4174 Dundas Street West - Official Plan Amendment and Zoning By-law Amendment Applications - Appeal Report

Date: March 15, 2023

To: Etobicoke York Community Council

Planning Application Number: 21 196623 WET 02 OZ and 22 178815 WET 02 OZ

Attachment 5: Site Plan

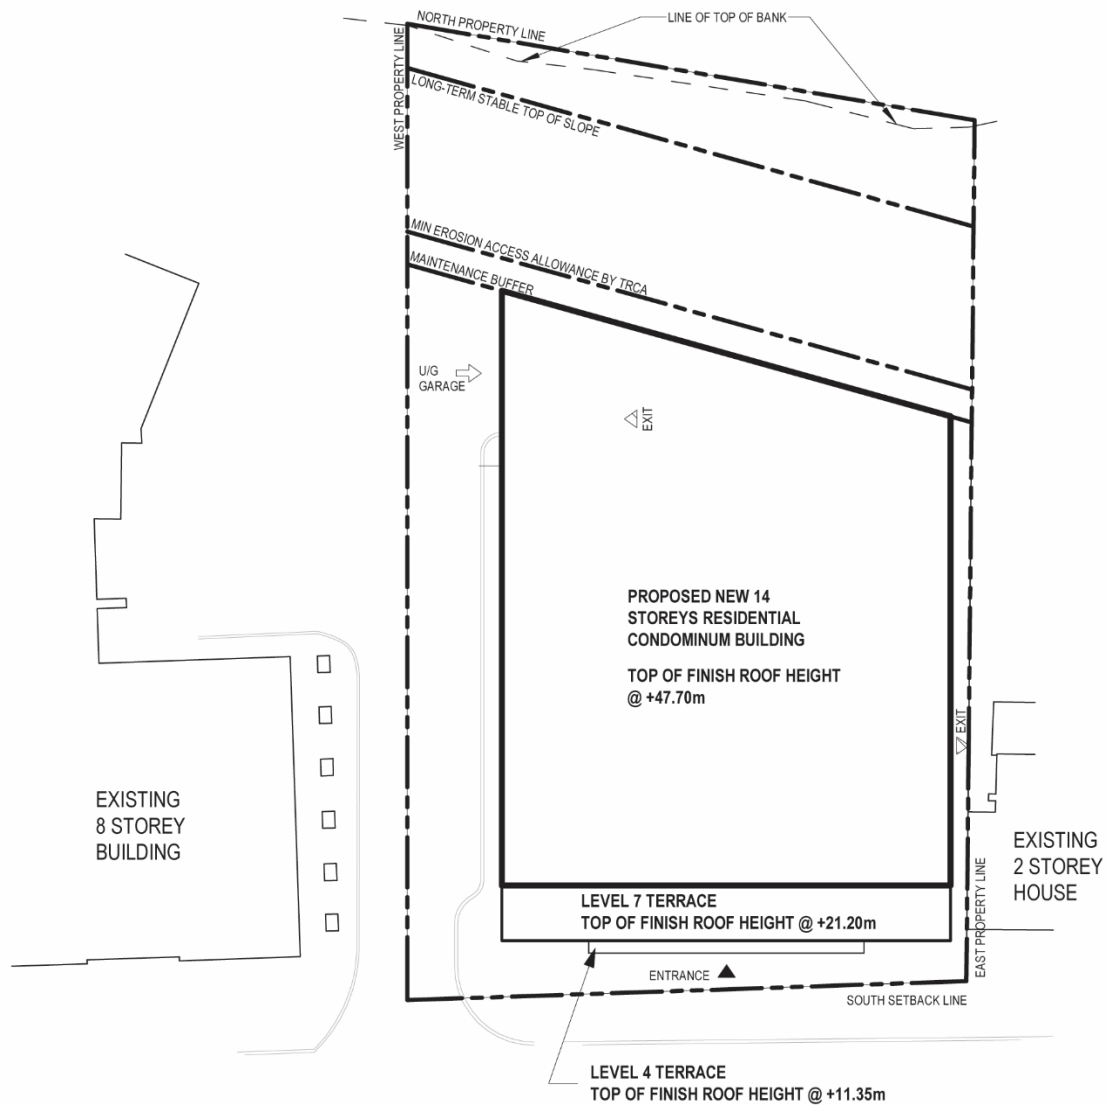
The site plan depicts a Type G loading space to accommodate on-site garbage truck circulation, however, the movements are encroaching into the 10-metre long term stable top of slope buffer. The Official Plan does not permit this type of encroachment into the 10-metre buffer. This loading space and associated movements should be integrated into the building and portion of the site outside of the buffer. There is also a Type B loading space provided for moving activity, however, this could be removed as it is not required.

Ravine and Natural Feature Protection staff do not support the Official Plan Amendment or Zoning By-law Amendment applications as the proposed garbage truck loading area will require significant encroachment into the 10-metre buffer from the long-term stable top of slope.

To facilitate regular on-going building maintenance (e.g., foundation repairs), TRCA staff will require a minimum three-metre building setback to the future open space block/new lot line. This applies to both above and below grade structures. The current proposal provides a two-metre setback.

The architectural plans submitted do not provide dimensions or labelling that would allow staff to evaluate whether the proposal satisfies the requirements for:

- Minimum 2.1-metre wide sidewalks;
- An adequate pedestrian zone width to support the proposed scale of development, TGS soil volumes and healthy and mature street tree planting; and
- A 0.4-metre road widening.

The conveyed lands and dimensions must be clearly delineated on the site plan and landscape plan.
